GNRO-2011/00017

SUBJECT: Request for Additional Information Regarding
Extended Power Uprate
Grand Gulf Nuclear Station, Unit 1
Docket No. 50-416
License No. NPF-29

Grand Gulf Nuclear Station, Unit 1 Extended Power Uprate

Response to Request for Additional Information

Figure 1 - Short Term Temperature Response - Main Steam Line Break

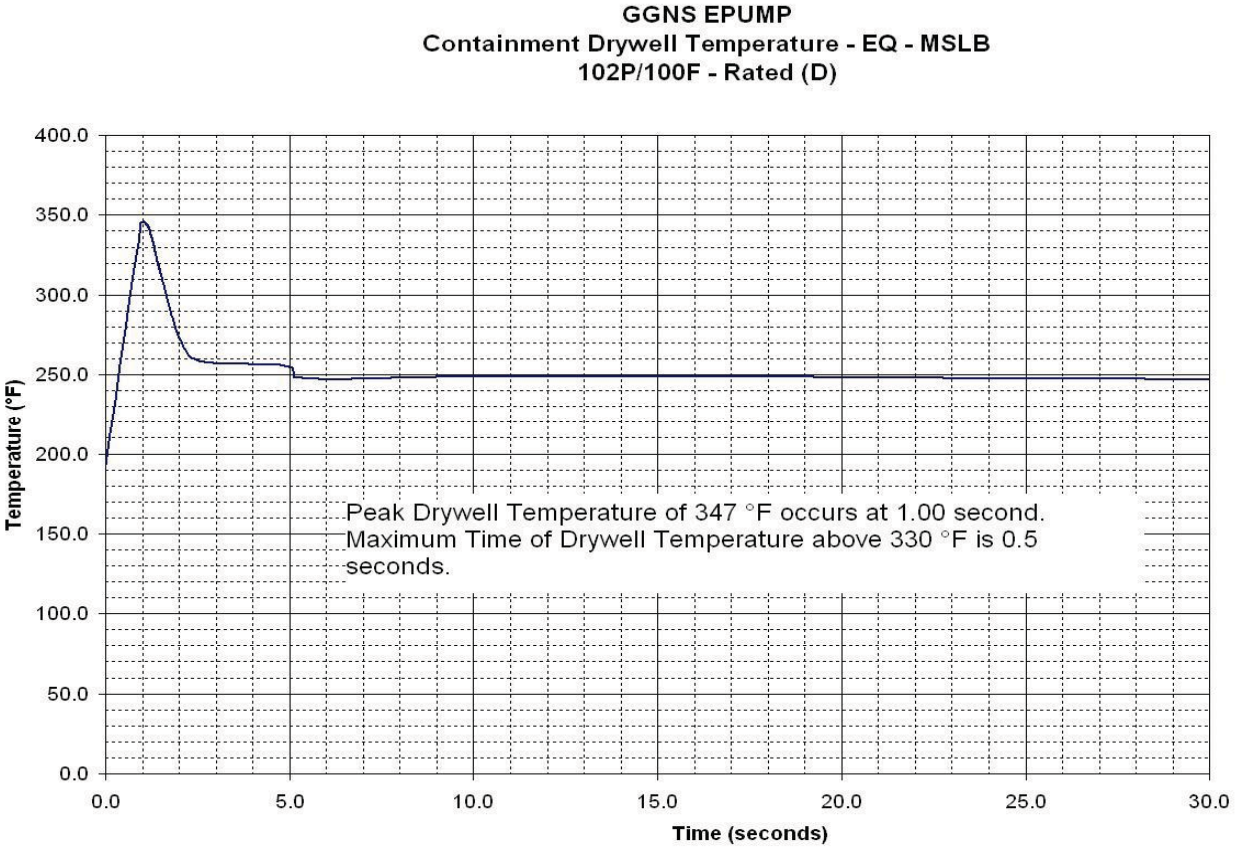
On page 2-10 of attachment 5B of its letter dated September 8, 2010, the licensee states that the qualification level peak temperature for the drywell is 340°F and the peak temperature for the EPU conditions was determined to be <340°F. However, the licensee stated that the EPU peak temperature ignores a short initial one-second transient to 347°F and that this transient would have an insignificant effect on the coating temperatures. Please discuss why the qualification testing remains bounding despite having a containment temperature that exceeds the test temperature profile.

The 347°F is a brief spike (or transient) in drywell temperature that happens within the first second of the accident (see Figure 1 - Short Term Temperature Response Main Steam Line Break), then drops below and stays below the 340°F design temperature. In regards to Environmental Qualification, the focus is on the temperature that the components and materials of interest attain. The protective coatings in containment do not instantaneously heat up to the temperature of the drywell environment; rather, the temperature response of the coatings is based on convective heat transfer properties and thermal capacity. Exposure to a very brief spike (one second) of elevated temperature is not nearly long enough to heat up the protective coatings much beyond their initial temperature condition (≤135°F per GGNS Technical Specifications). Rather, the analysis demonstrating that the drywell temperature remains below 340°F confirms that the ultimate peak temperature of the coatings themselves would remain below this qualification temperature, in conformance to design requirement.

Figure 1: GGNS SFP Map

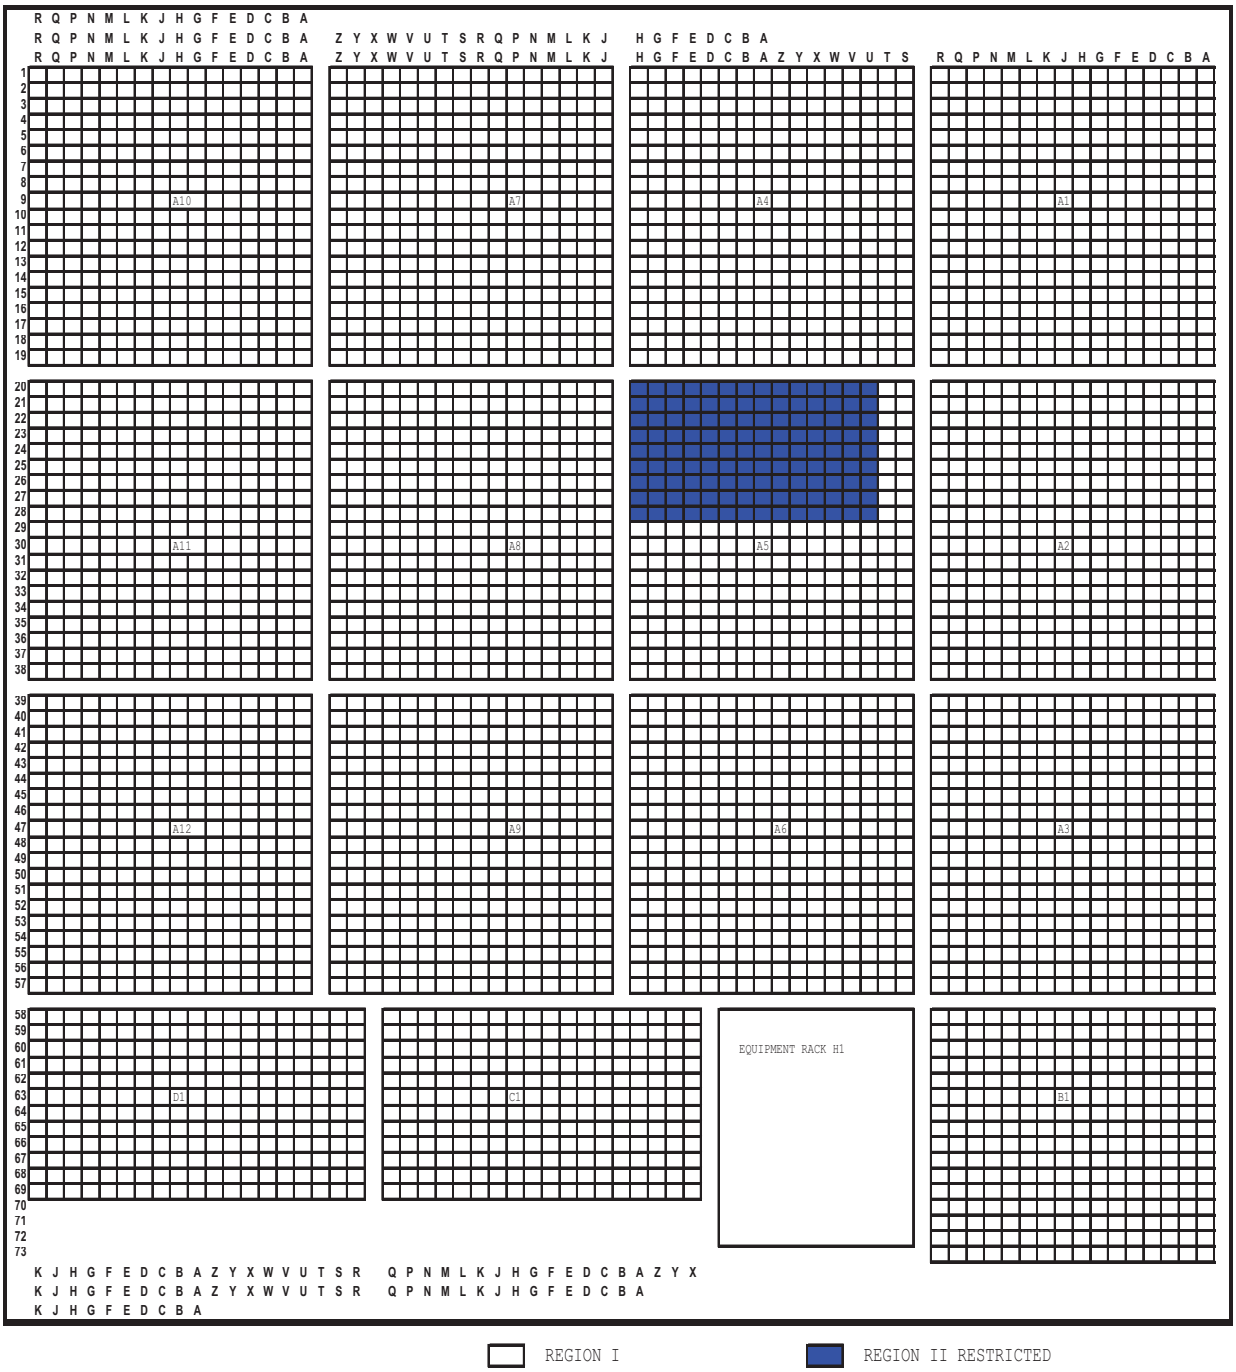
Please discuss the extent to the Region II expansion as it relates to the degradation in the Boraflex panels in the spent fuel pool. In other words, discuss how the new Region II locations are determined and added after each Blackness and BADGER test campaign. Please provide a spent fuel pool map illustrating the current Region I and II locations.

As described in response to RAI # 2, new Region II locations are established based on Racklife calculations. If either the Region I Racklife areal density or dose criteria are not met for a given Boraflex panel, the two fuel storage cells face-adjacent to that panel are classified as Region II storage locations. Region II storage locations are controlled in one of two ways:

The spent fuel map, illustrating the current region designations of the storage cells, is provided in Figure 1. Note that the current Region II area has not been expanded since its initial creation in 2000.
